DEER2015 Update Comments

SCE Comments on Packaged and Split Air Conditioning Equipment

Residential SEER-rated Air Conditioners less than 45 kBtuh

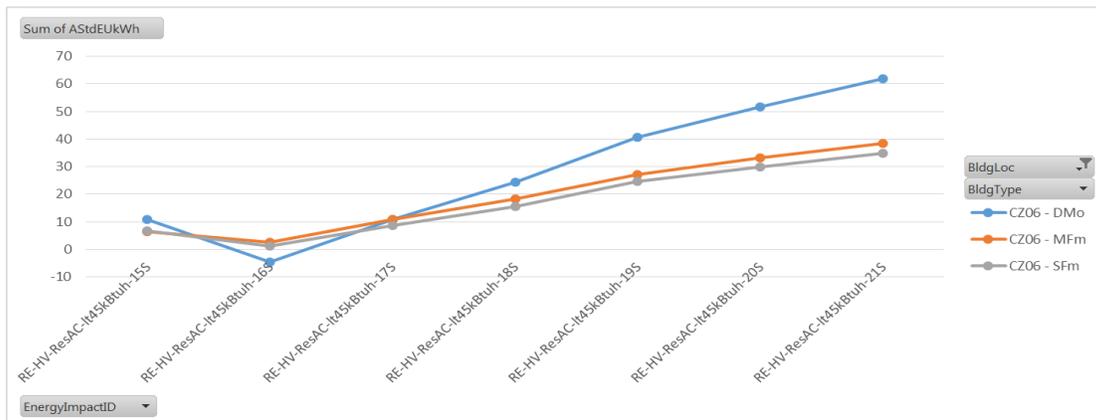
1. DEER 2015 measures for residential and non-residential air conditioners less than 45kBtuh. A parallel exercise in these two categories conducted for comparison's sake yielded different energy savings trends when a similar output was expected. In the graph directly below, the 16 SEER units have lower savings (negative savings for DMO) than the 15 SEER units for residential split AC system measures that are less than 45 kBtuh. The graph further below, for non-residential split AC system measures less than 45 kBtuh, shows 16 SEER units as having higher savings than 15 SEER units. Since both measures illustrated below are essentially the same SEER-rated air conditioner units, it is unclear why the energy saving trend from 15 SEER to 16 SEER units differs by sector. **SCE asks that CPUC Staff provide explanation for the difference in output.**

The reason for this difference stems from the fact that supply air fans operate continuously for commercial buildings, and they cycle with cooling and heating for residential buildings. The annual performance of the 16 SEER systems depends heavily on the two speed fan operation; the full load efficiency for the 16 SEER systems is actually lower than for the 15 SEER systems. Since the fan operates significantly more hours per year for the non-residential buildings, there is much greater possibility for savings for those buildings.

SEER-rated split AC 45 to 55

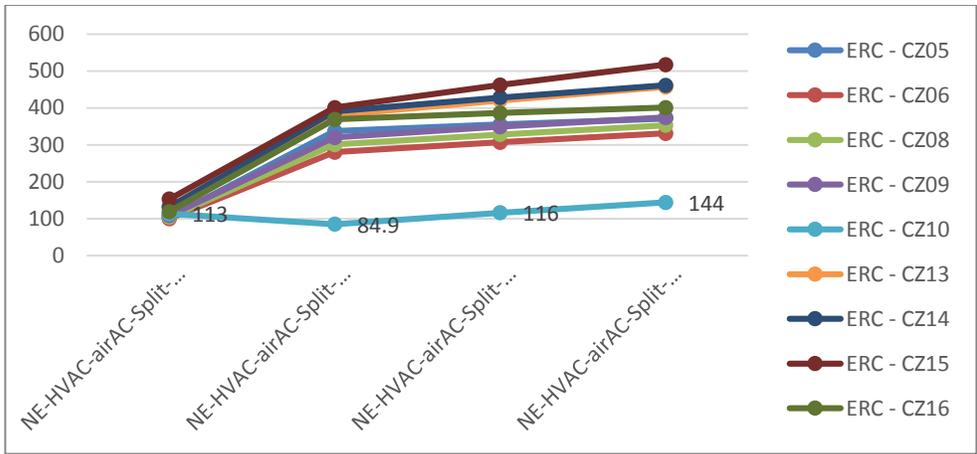
- ERC CZ10 energy impact values are not updated with two-speed fan operation as defined in the measure definition. **SCE asks that CPUC Staff clarify or update ERC CZ10 energy impact values accordingly.** Reference tables and charts are provided below.

The DEER team has reviewed the energy impacts for these measures and has updated the values for ERC in climate zone CZ10.

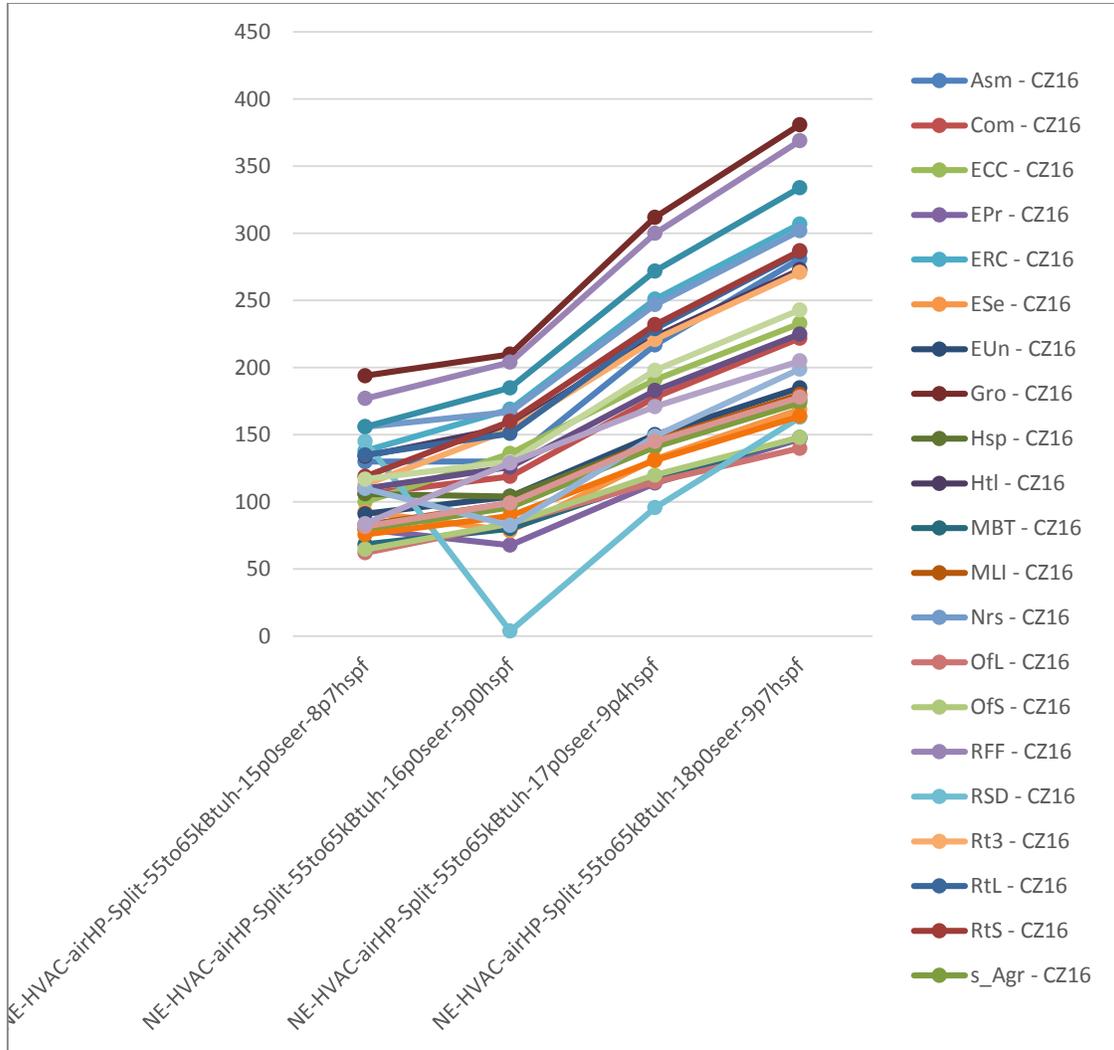
6. Energy impacts for HP measures for Sit Down Restaurants (RSD). An anomaly was found for the HPsplit system (55 to 65) in RSD building type CZ 16. A screen shot is included for more detail. **SCE requests CPUC Staff provide an explanation or correction for the anomaly.**

The DEER team has updated the SEER-rated HP measures as they apply to the Sit-Down restaurant, eliminating the near-zero and negative impacts for some climate zones.
